Illinois Department of Transportation

SUBJECT: Centralia Municipal Airport
Centralia, Illinois
Marion County
Illinois Project Number: ENL-4661
Contract No. CE036
Item No. 03A, March 8, 2019 Letting
Addendum A

NOTICE TO PROSPECTIVE BIDDERS

CONSTRUCT ACCESS TAXIWAY TO RUNWAY 9

SHEET 7 OF 25

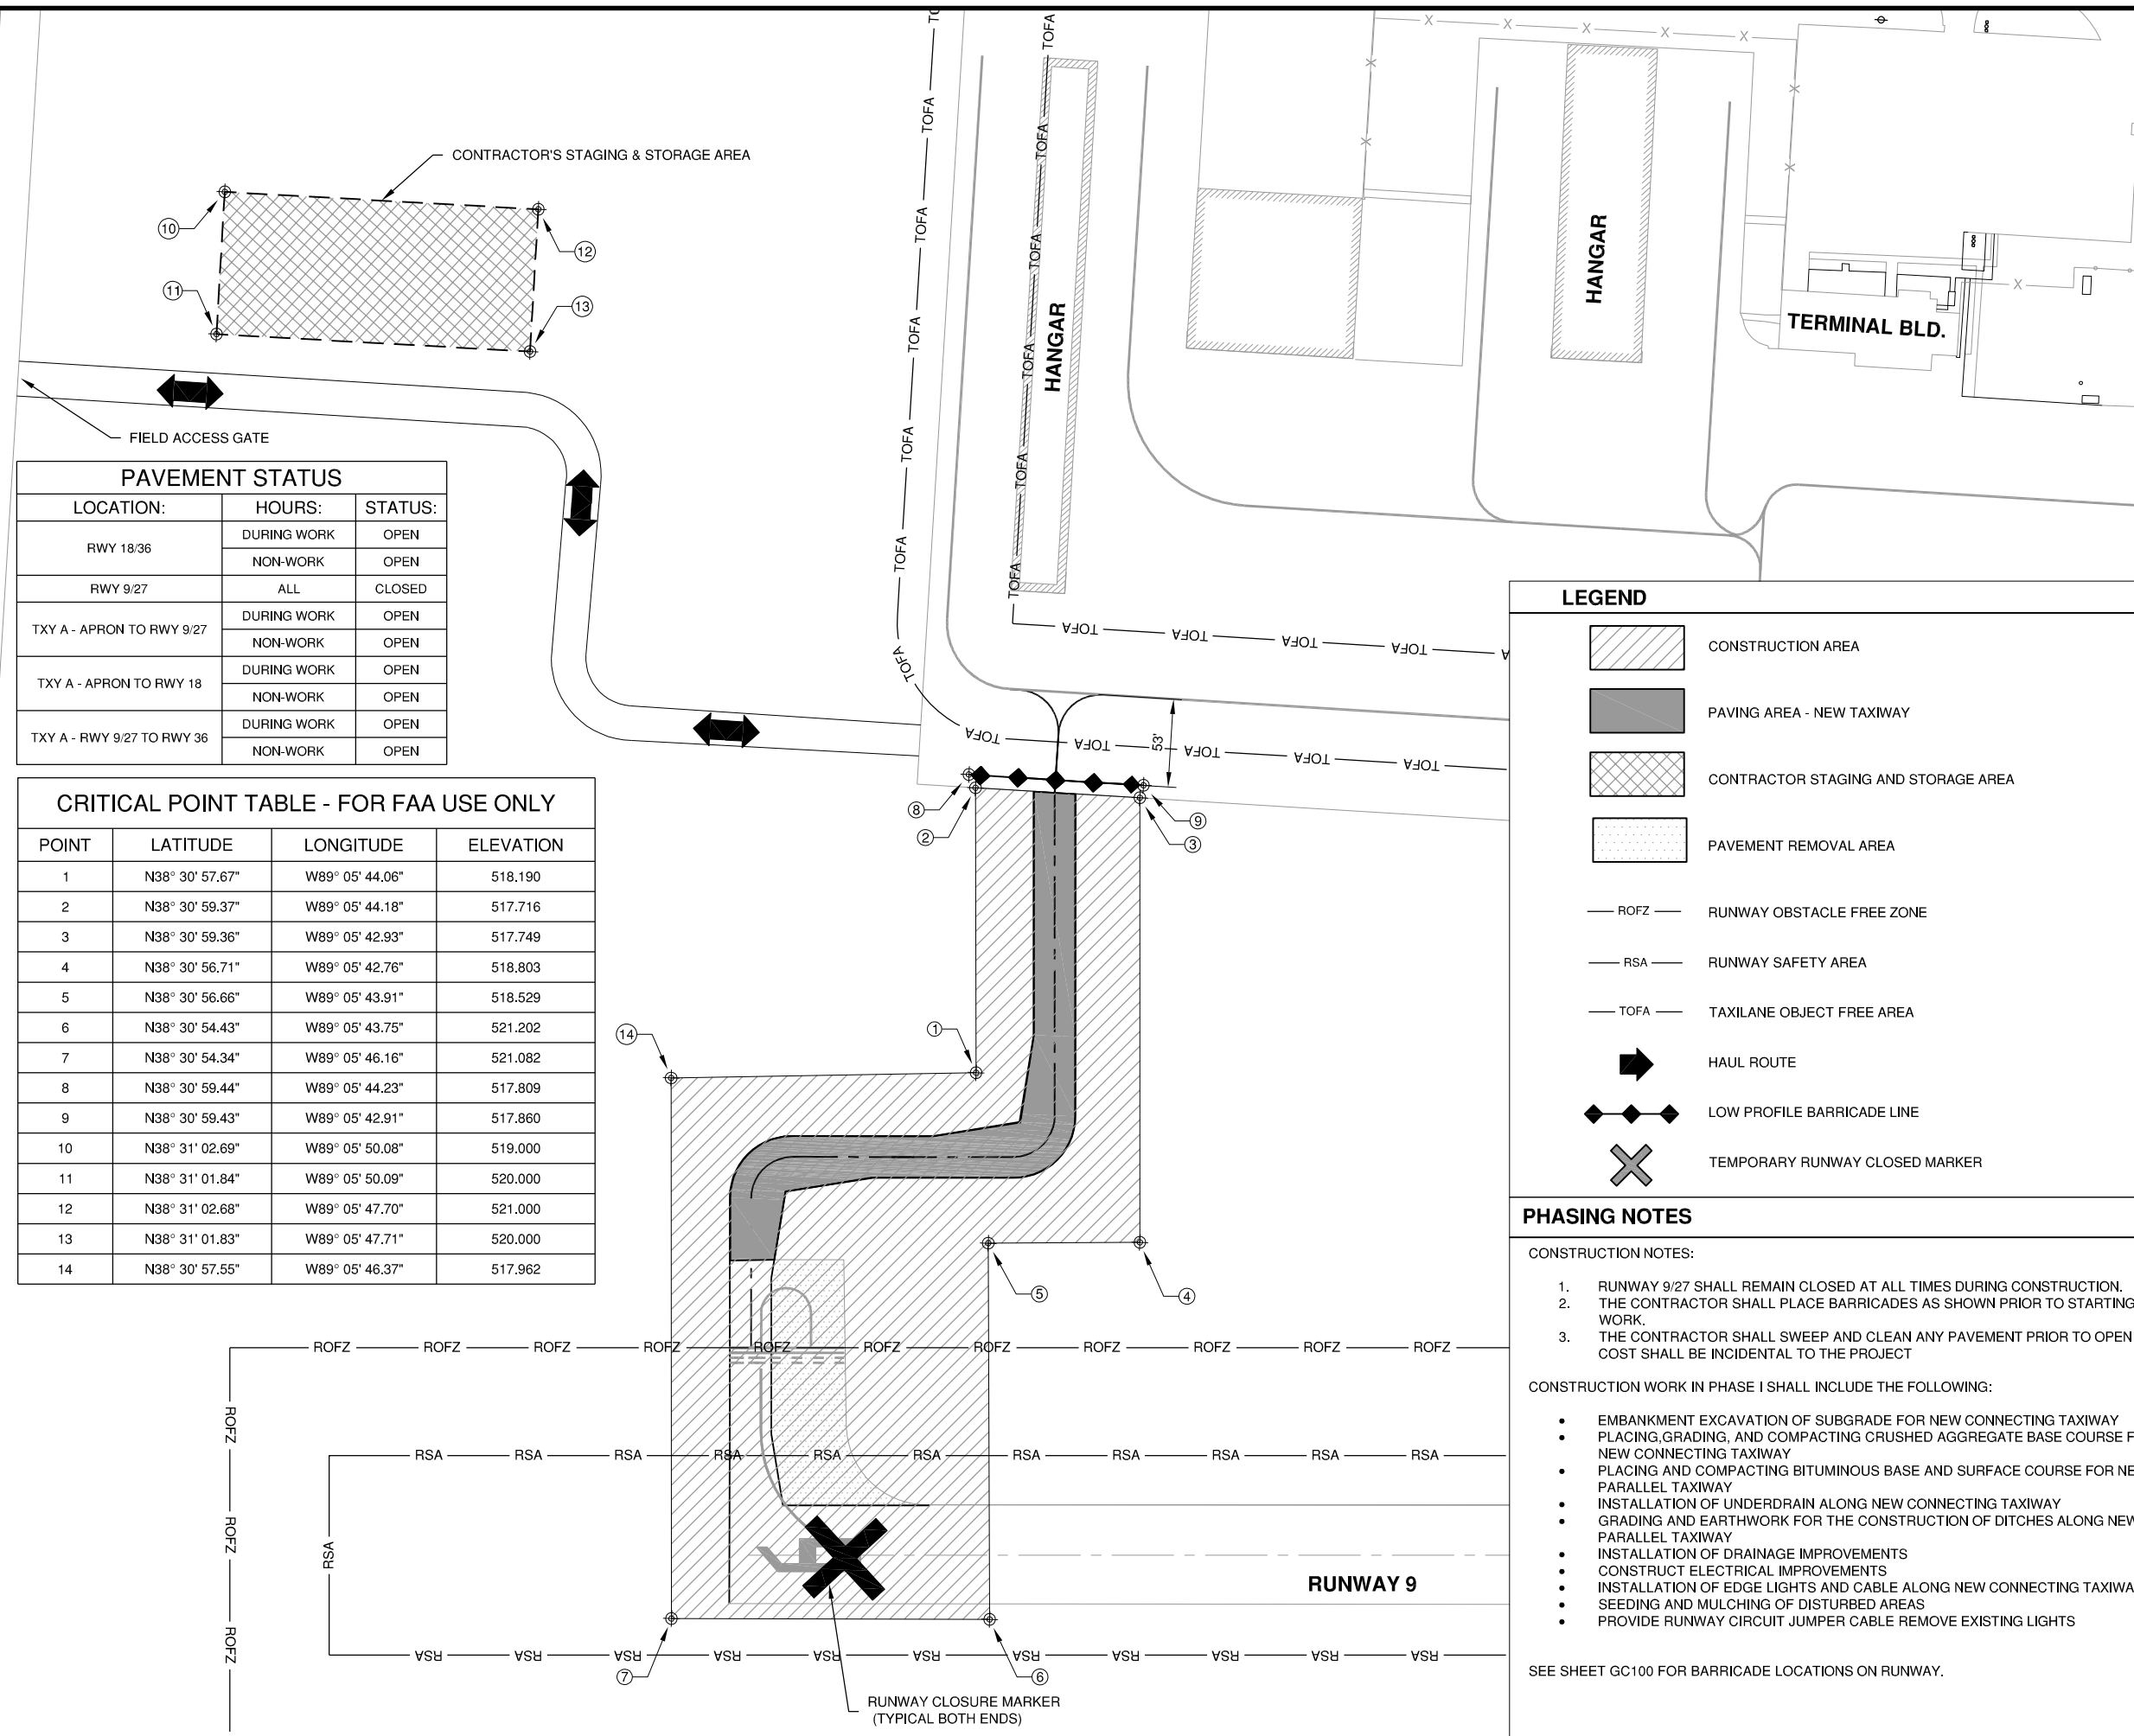
CRITICAL POINT TABLE - FOR FAA USE ONLY

POINT	LATITUDE	LONGITUDE	ELEVATION
1	N38° 30' 57.67"	W89° 05' 44.06"	518.190
2	N38° 30' 59.37"	W89° 05' 44.18"	517.716
3	N38° 30' 59.36"	W89° 05' 42.93"	517.749
4	N38° 30' 56.71"	W89° 05' 42.76"	518.803
5	N38° 30' 56.66"	W89° 05' 43.91"	518.529
6	N38° 30' 54.43"	W89° 05' 43.75"	521.202
7	N38° 30' 54.34"	W89° 05' 46.16"	521.082
8	N38° 30' 59.44"	W89° 05' 44.23"	517.809
9	N38° 30' 59.43"	W89° 05' 42.91"	517.860
10	N38° 31' 02.69"	W89° 05' 50.08"	519.000
11	N38° 31' 01.84"	W89° 05' 50.09"	520.000
12	N38° 31' 02.68"	W89° 05' 47.70"	521.000
13	N38° 31' 01.83"	W89° 05' 47.71"	520.000
14	N38° 30' 57.55"	W89° 05' 46.37"	517.962

SUBGRADE REPAIR
N.T.S.

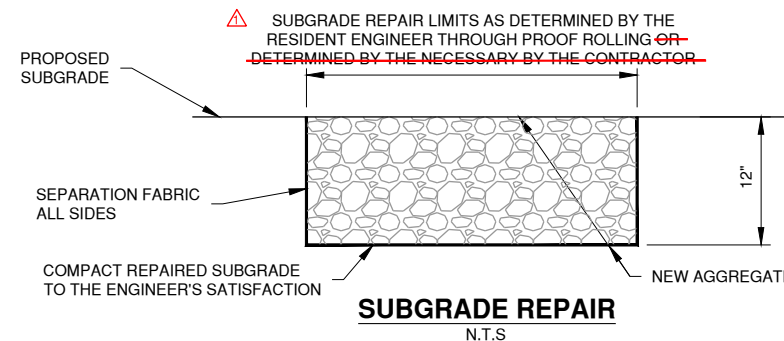
NOTES:
EDGE DRAINS ARE TO BE INSTALLED AFTER SUBGRADE REPAIR AND AGGREGATE BASE.

1. THE FOLLOWING SHALL BE THE STEPS TAKEN TO REPAIR THE SUBGRADE:
 - 1.1. REMOVE SOIL SUBGRADE TO A DEPTH OF 12" OR AS DIRECTED BY THE RESIDENT ENGINEER.
 - 1.2. COMPACT THE SUBGRADE TO THE SATISFACTION OF THE RESIDENT ENGINEER.
 - 1.3. PLACE SEPARATION FABRIC ON TOP OF THE COMPACTED SUBGRADE AND UP THE SIDES OF THE EXCAVATION. CONSIDERED INCIDENTAL TO ITEM.
 - 1.4. PLACE AND CONSOLIDATE AGGREGATE TO THE SATISFACTION OF THE RESIDENT ENGINEER.
2. AGGREGATE SHALL BE IDOT GRADATION CA-06, CA-07, OR OTHER ALTERNATE MATERIAL PROPOSED BY THE CONTRACTOR AND APPROVED BY THE ENGINEER.
3. THE FOLLOWING SHALL BE INCIDENTAL TO THE SUBGRADE REPAIR PAY ITEM (AR152511):
 - 3.1. UNCLASSIFIED EXCAVATION
 - 3.2. SUBGRADE PREPARATION
 - 3.3. SEPARATION FABRIC
 - 3.4. AGGREGATE

CG101
SHEET 12 OF 25

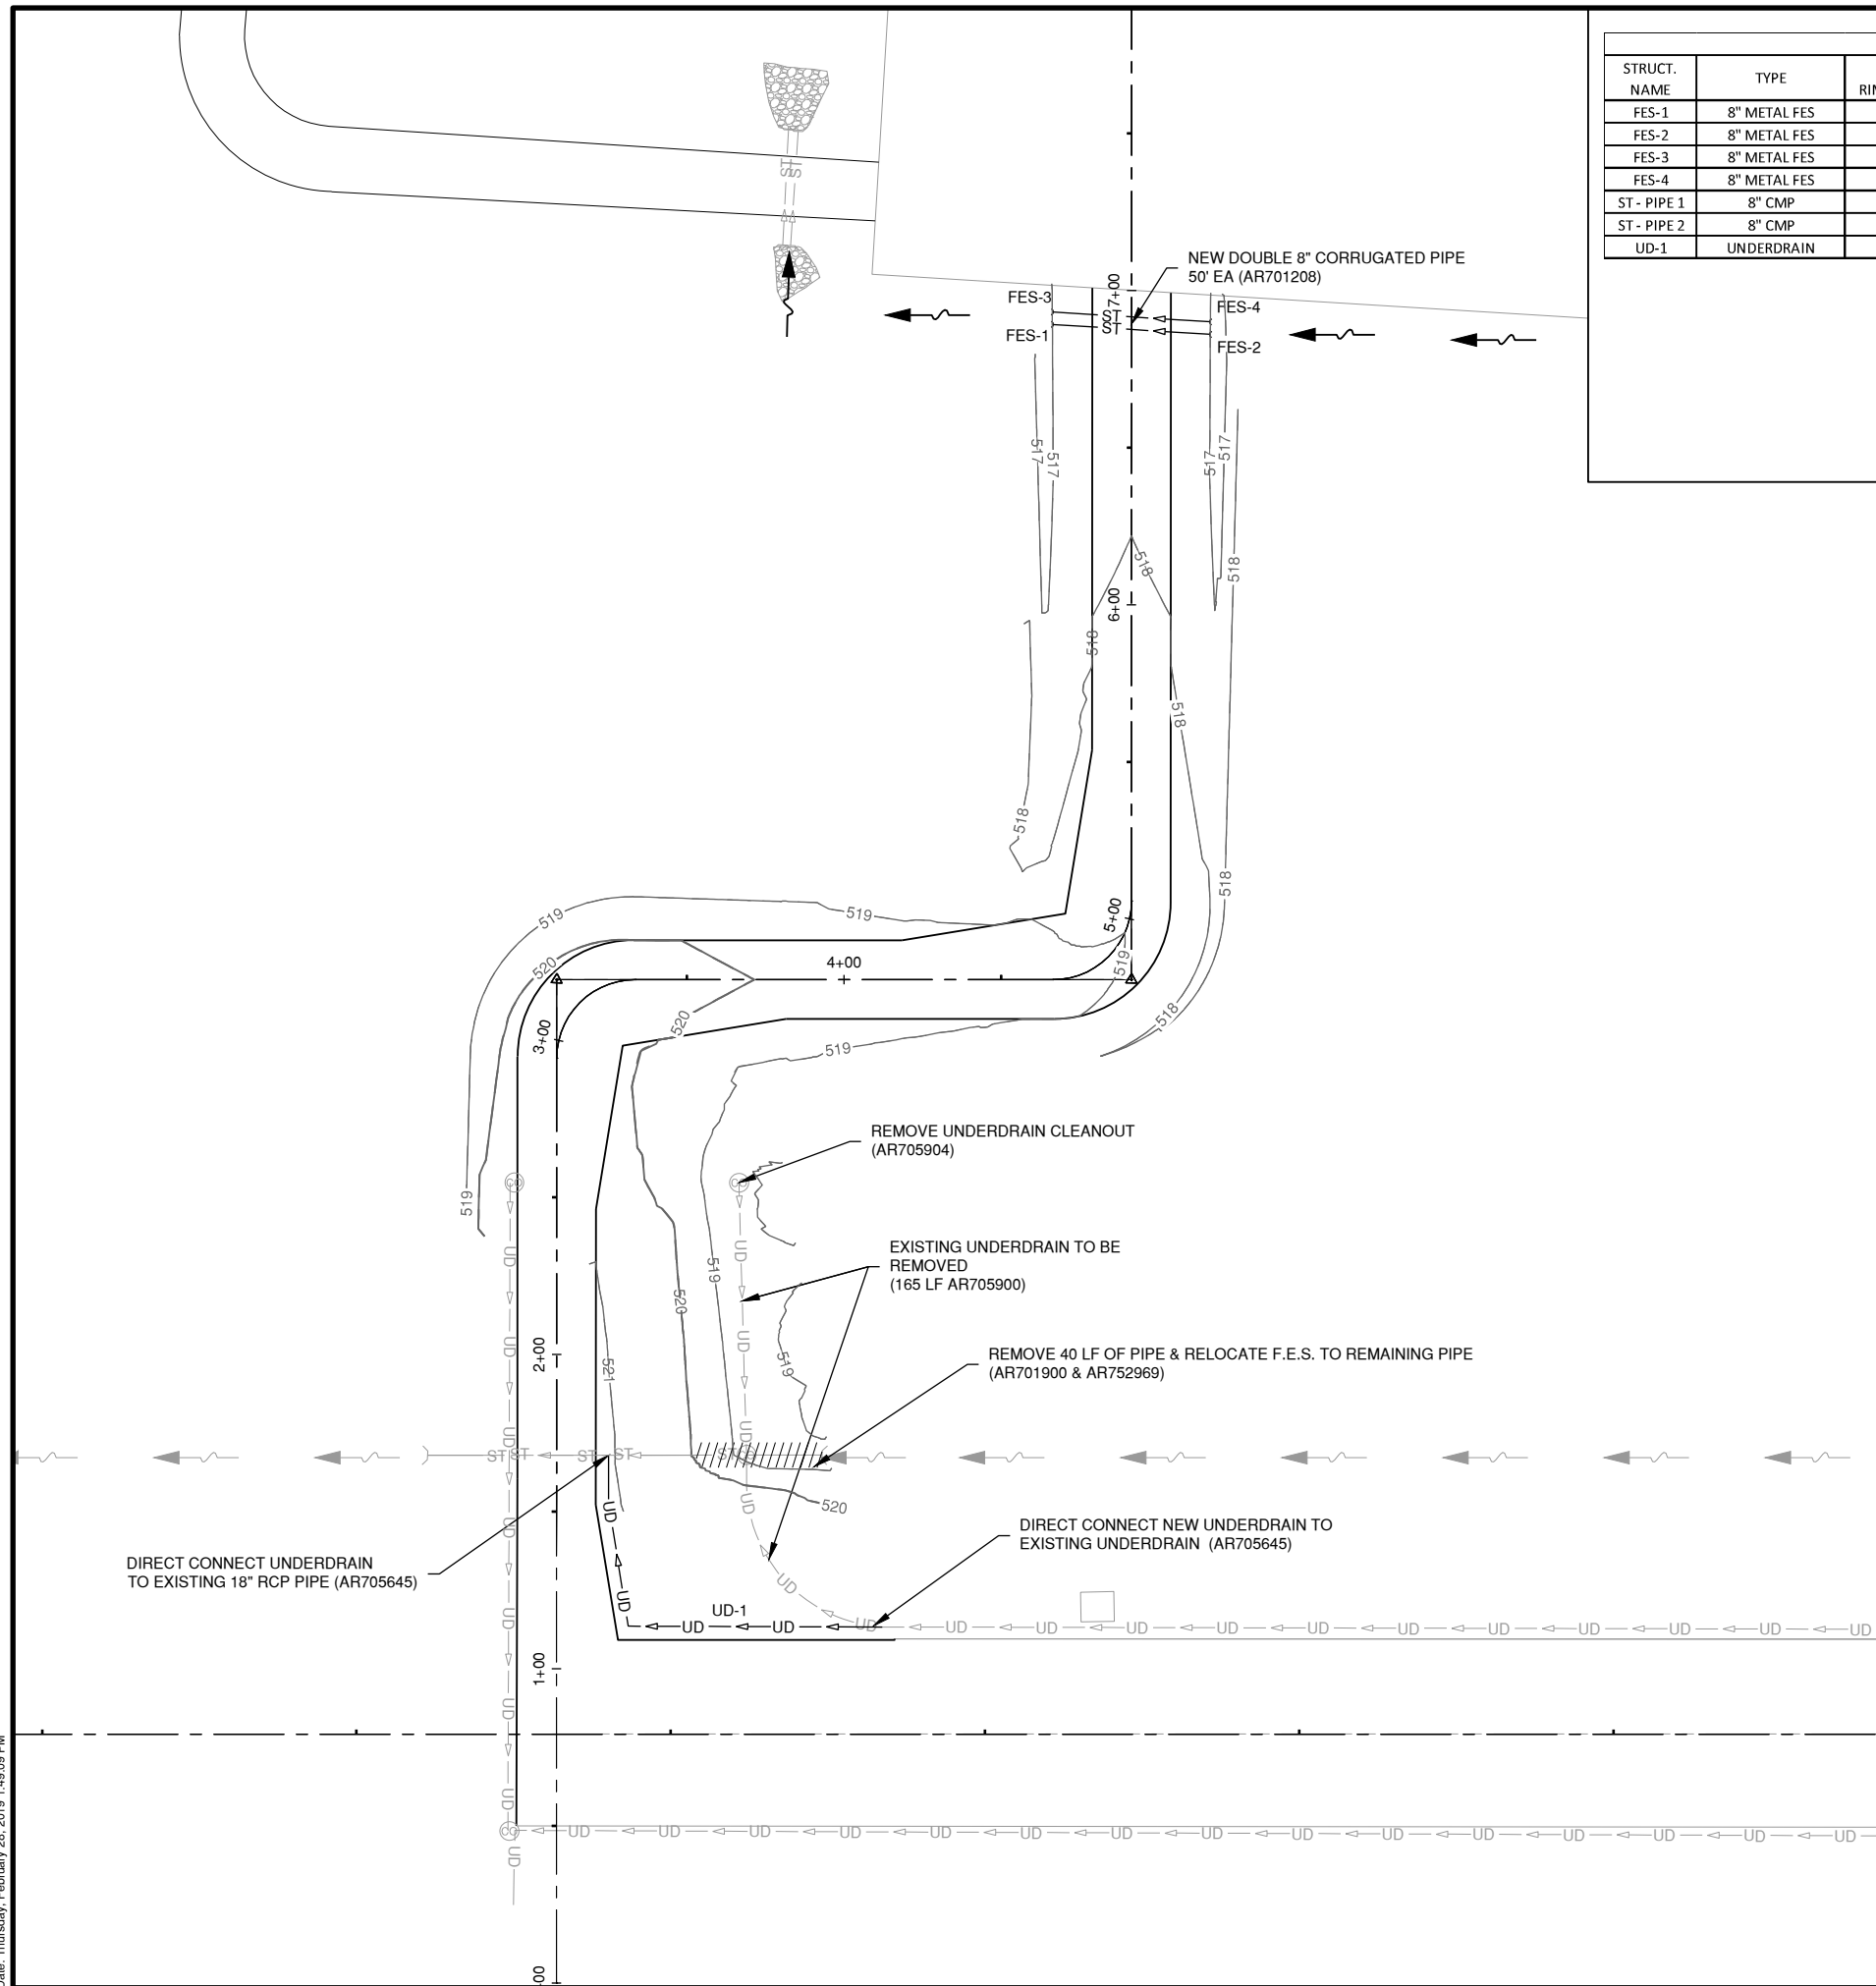
1. UNDER DRAINS ARE TO BE INSTALLED AFTER ~~LIME MODIFICATION~~ SUBGRADE REPAIR (WHERE REQUIRED) AND PLACEMENT OF AGGREGATE BASE COURSE.
